Logan-Union-Champaign regional planning commission

Zoning & Subdivision Committee

Thursday, December 14, 2017

Staff Report – Darby Braeside

7	CLAVERTHOUSE COURT PLAN AND PROFILE	CITY OF PLAIN CITY, OHIO DARBY BRAESIDE PRELIMINARY PLAN PHASE 2-4 UNION COUNTY OHIO	PREPARED FOR: DARBY BRAESIDE, LLC	<div>TECHNICAL SKILL. CREATIVE SPIRIT. www.MannikSmithGroup.com</div>

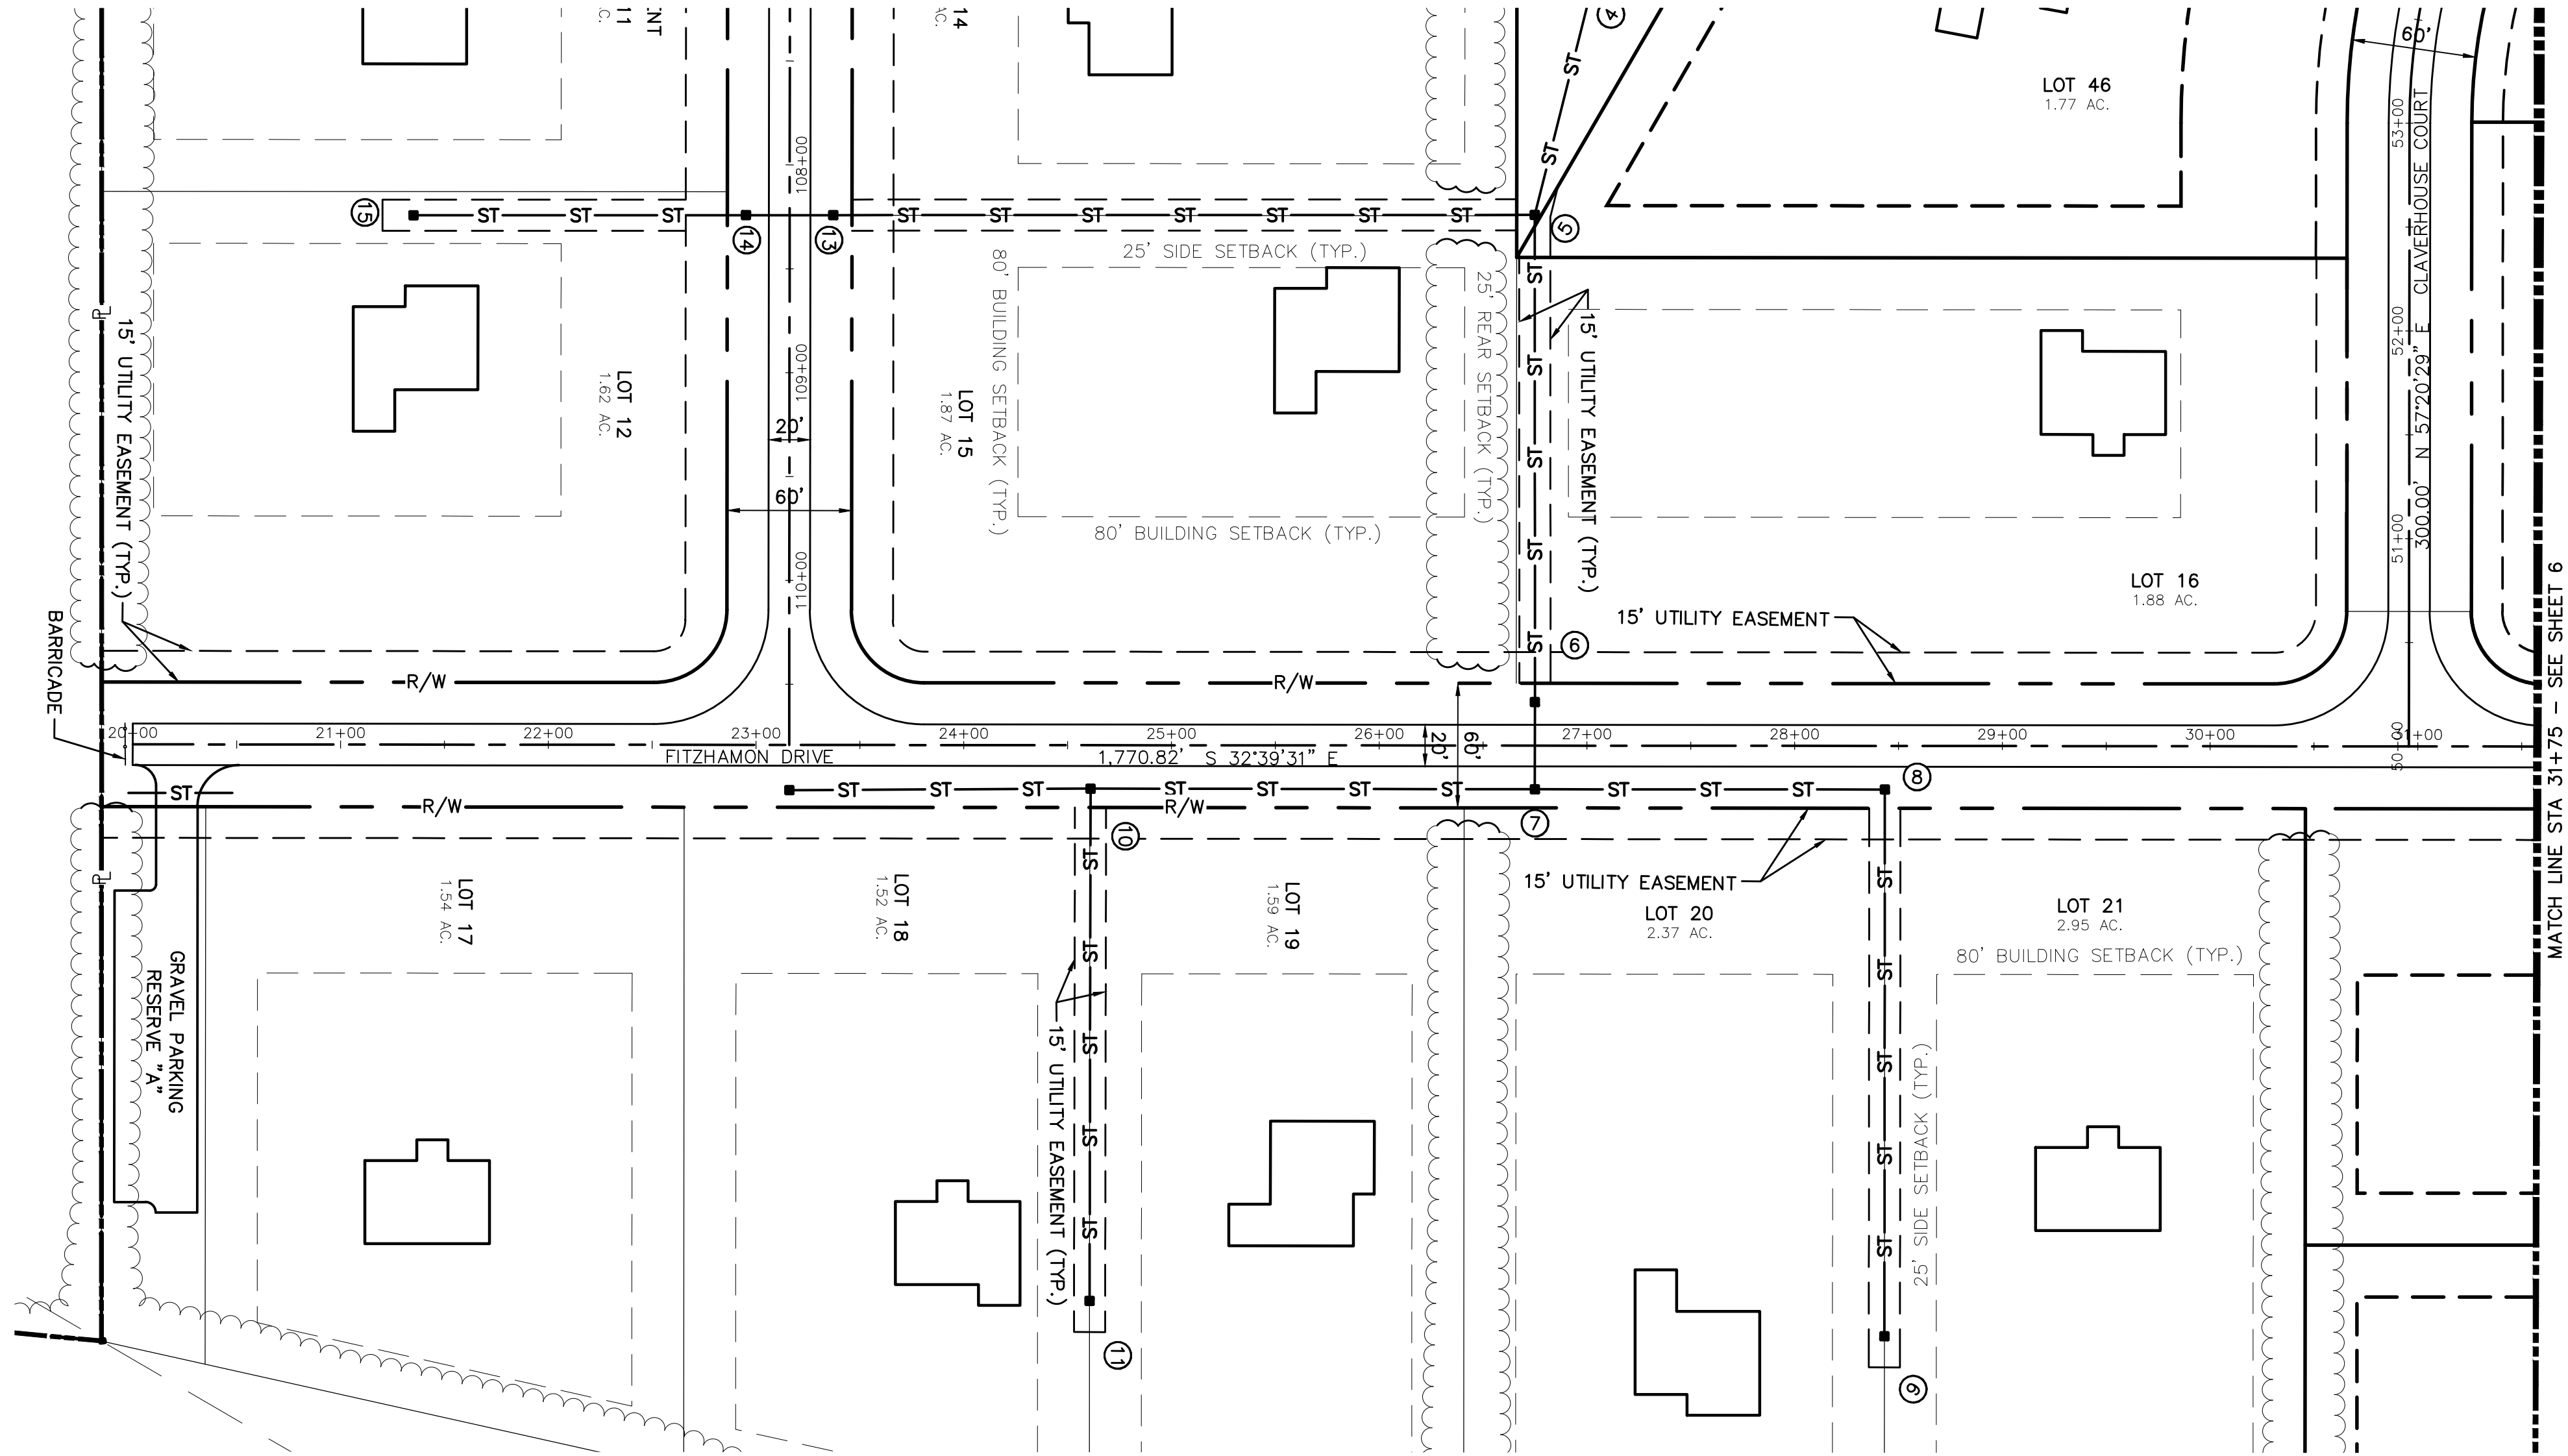
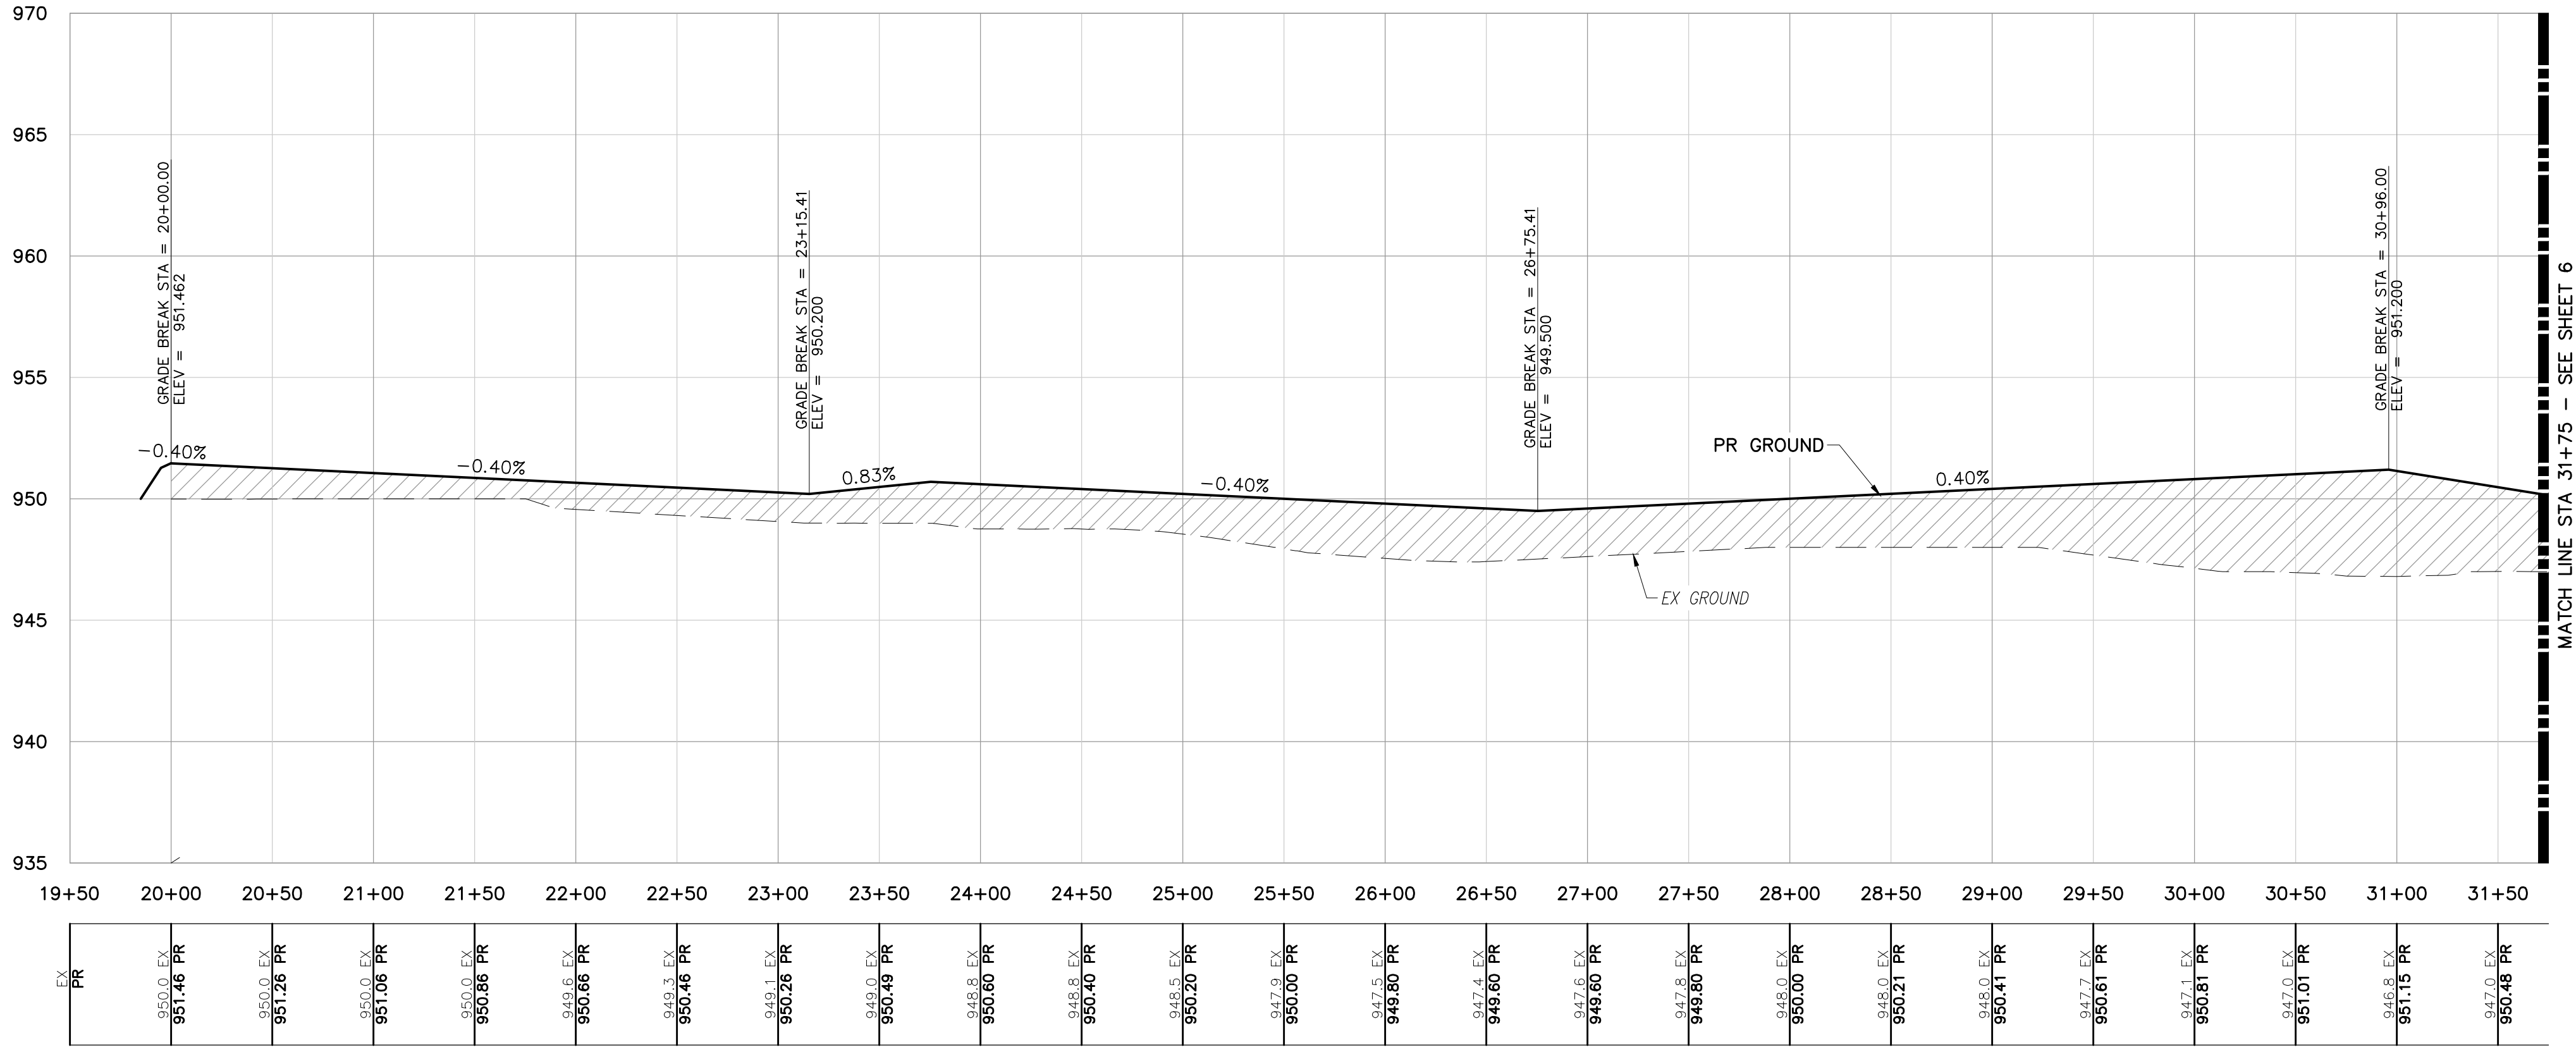
- 3) Sheet 3 of 19 – Existing Conditions
 - a) No comments
- 4) Sheet 4-8 of 19 – Roadway Plan & Profiles
 - a) URE to work with developer Engineering firm to establish offset easements between lots for primary or secondary facilities.
